From: Stephen Oates
Sent: 18 July 2017 10:21
To: DevPlans Team shared mailbox
Subject: Local Development Plan 2 - Candidate Sites, Lawrenny
Attachments: 170717 Candidate sites objections Stephen Oates.pdf; 170413 Pre_planning response S Oates.pdf; 170717 S Oates Pre Deposit Questionnaire LDP.docx

COMMENTS ON LDP CANDIDATE SITES BY STEPHEN OATES

Candidate Site 045 - Home Farm, Lawrenny

LAWRENNY DEVELOPMENT – PRE-PLANNING CONSULTATION

Proposed amendments to site 045 boundaries and access arrangements

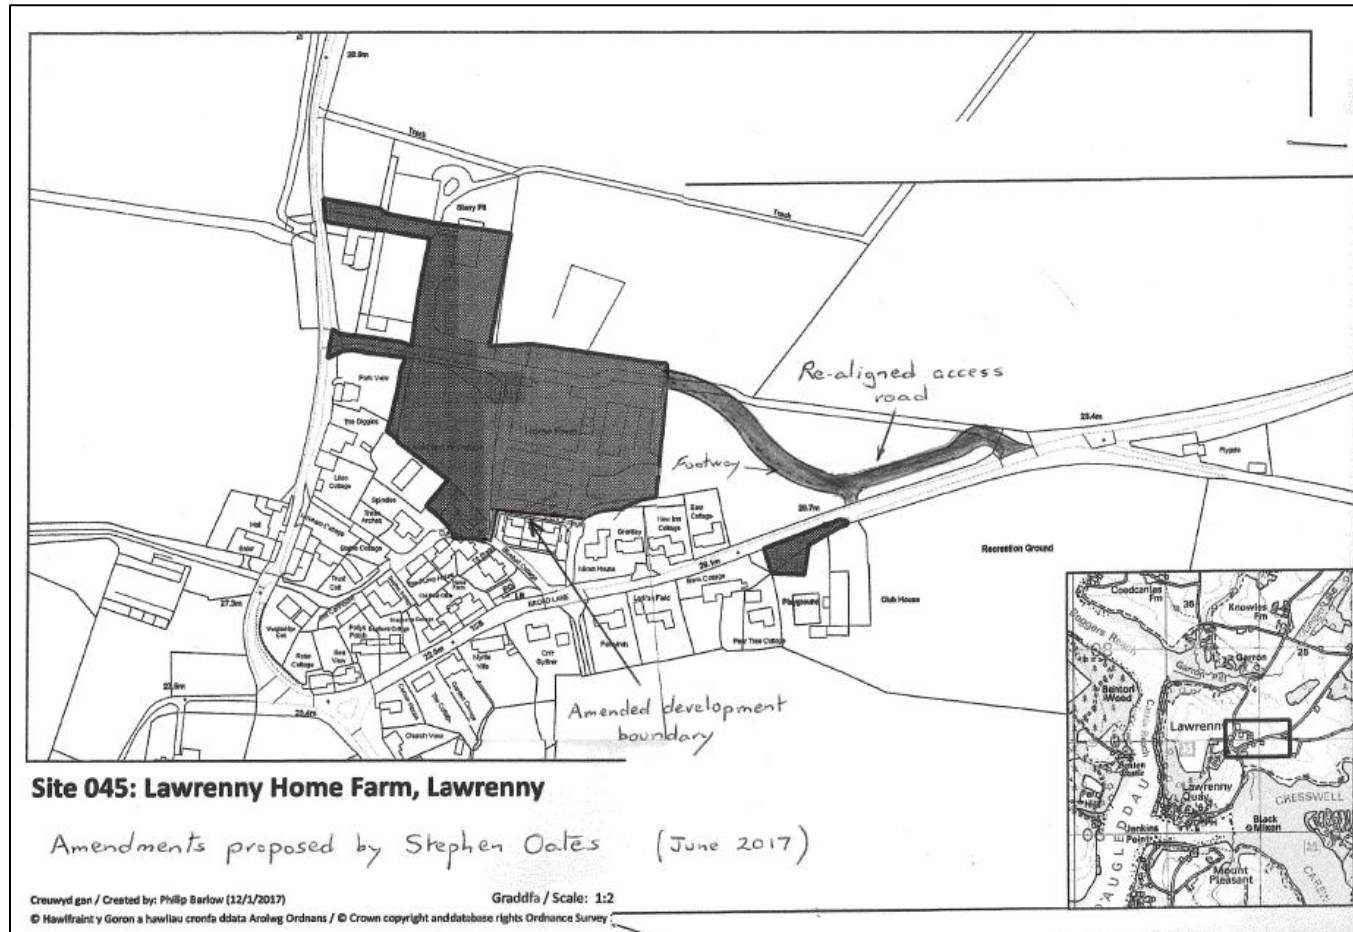
I have illustrated suggestions to modifications to the development boundary of site 045 (Home Farm, Lawrenny) in the sketch on the following page (Appendix 1).

- i) reduce scope of intrusion into adjoining agricultural land by re-aligning eastern access road; and
- ii) eliminate traffic intrusion into existing village estate by preventing vehicular access to site 045 from the south.
